CRITICAL SERVICE BULLETIN

CSB 01-1
TECHNICAL PORTIONS
FAA APPROVED

SUBJECT: FUEL PUMP INSPECTION and SEAL LEAK TEST

**FIGURE 1
FUEL PUMP ASSEMBLY-COMplete
(TYPICAL)**

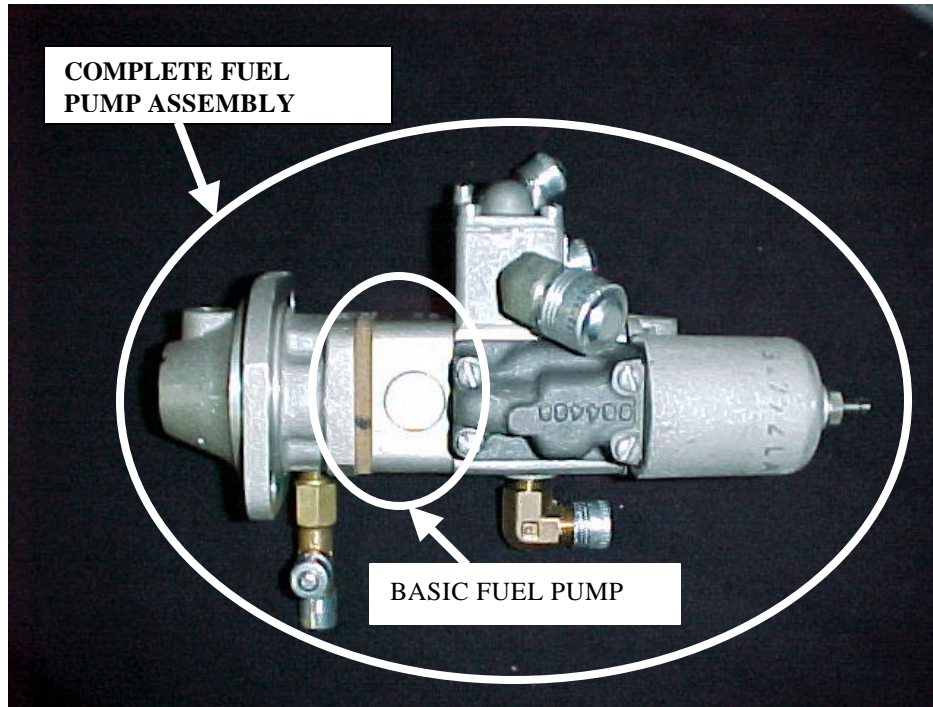
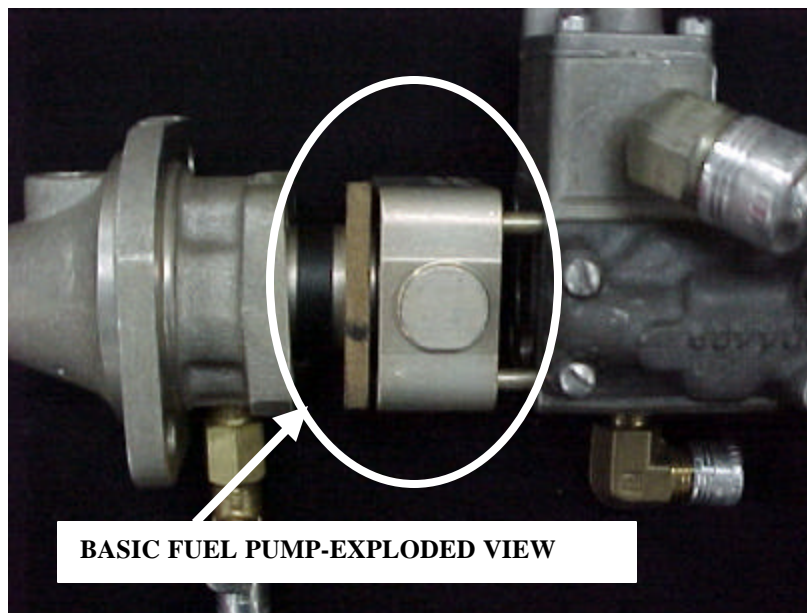
AFFECTED: IO-240, IO-360, IO-346, O-470-G7, O-470-G10, O-470-GCI, IO-470, GIO-470, IO-520, LIO-520, IO-550, GIO-550, LTSIO-360, TSIO-360, TSIO-470, TSIO-520, TSIO-550, TSIOL-550, GTSIO-520 model engines with P/N 642932-1, 2, 3 & 4 basic fuel pump ① manufactured between July 1, 1998, and May 31, 2000 ②.

Any of the above listed engine models that have had an engine driven fuel pump overhauled using a new P/N 642932-1, 2, 3, or 4 basic fuel pump ① between July 1, 1998, and November 26, 2000.

① Refer to Figures 1 and 2

FIGURE 3
Affected Basic Fuel Pump
P/N's 642932-1, -2, -3, & -4

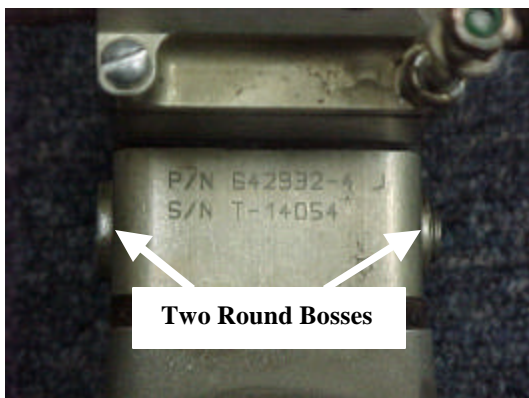
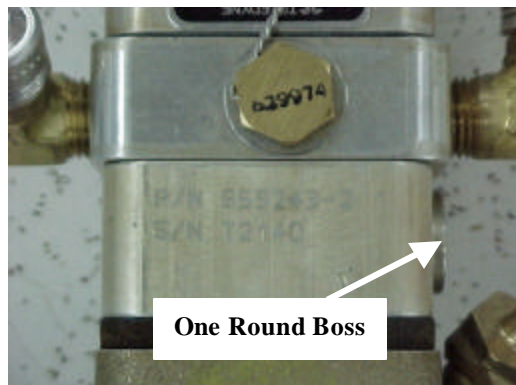
Affected engine driven fuel pump assemblies were manufactured utilizing basic fuel pumps P/N's 642932-1, 642932-2, 642932-3 and 642932-4. These basic fuel pumps may be identified by the presence of two (2) round bosses located on opposite sides of the basic fuel pump housing. Refer to Figure 3.

New basic fuel pumps P/N's 655243-1, 655243-2, 655243-3 and 655243-4 having only one round boss are not affected by this service bulletin. Refer to Figure 4.

(basic fuel pumps with one round boss are not affected by this service bulletin)

FIGURE 5
Fuel Pump Overboard Drain Tube
(Typical)

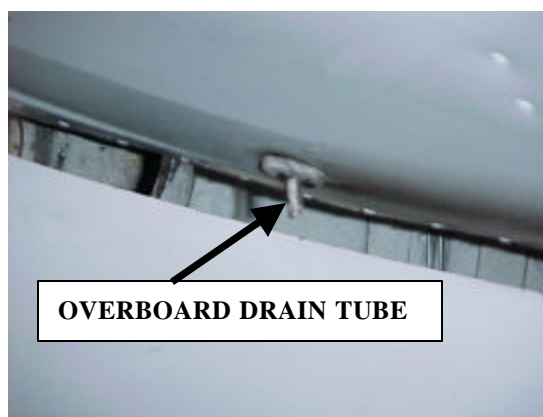
1. Locate the engine driven fuel pump assembly basic fuel pump seal overboard drain tube that exits the engine lower cowling.

6. Turn the aircraft Master Switch ON.
7. Turn the aircraft electric fuel boost pump ON, to the high position.
8. Have an assistant observe the engine driven fuel pump assembly basic fuel pump seal overboard drain tube for evidence of fuel discharge. See Figure 5.
9. If there is no visible indication of fuel being discharged from the fuel pump assembly basic fuel pump seal overboard drain tube make an engine logbook entry verifying compliance with TCM CSB 01-1.
10. If there is visible discharge of fuel from the engine driven fuel pump assembly basic fuel pump seal overboard drain tube proceed to step 11.
11. Locate the engine driven fuel pump assembly basic fuel pump seal drain tube connection at the engine driven fuel pump. Refer to Figure 6.

FIGURE 6
Fuel Pump Seal Drain Connection (Typical)

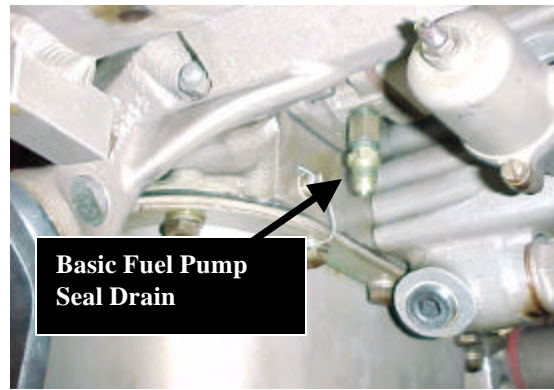
12. Isolate the basic fuel pump seal drain by disconnecting the seal drain tube at the fitting. Refer to Figure 6.
13. Repeat steps 6 and 7 having the assistant observe the fuel pump assembly basic fuel pump seal drain fitting at the fuel pump assembly for evidence of fuel discharge.
14. If no fuel discharge is noted, reconnect the fuel pump assembly basic fuel pump seal drain tube. Make an engine logbook entry indicating compliance with CSB 01-1.

15. If fuel discharge is noted, proceed to Part B.
